FULL HISTORIC REVIEW

ACTIVITY NUMBER:	SD-1125-00180
RELATED ACTIVITY NUMBERS:	TC-RES-1225-04525
LOCATION:	424 E 16TH ST (PARCEL #117071050)
ZONING:	HO-3
HISTORIC ZONE/DISTRICT:	ARMORY PARK HPZ
APPLICANT:	PAUL DOMINGUEZ
PROJECT NAME:	GARAGE CONVERSION TO STUDIO
STAFF CONTACT:	MICHAEL TAKU, HP LEAD PLANNER

Exhibit A: Google Street View images showing changes between 2011 and 2025

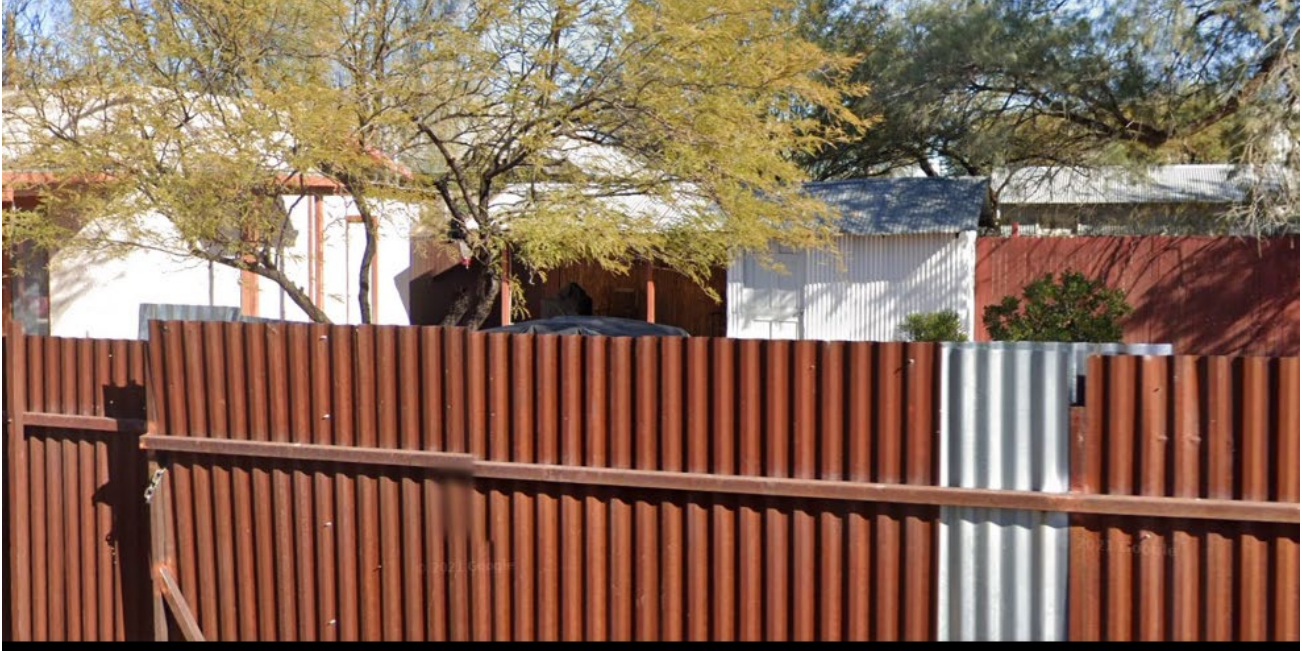
Two exhibits are provided below to help inform discussion. Exhibit A includes Google Street View imagery between 2011 and 2025 and Exhibit B shows aerial imagery between 2010 and 2026.
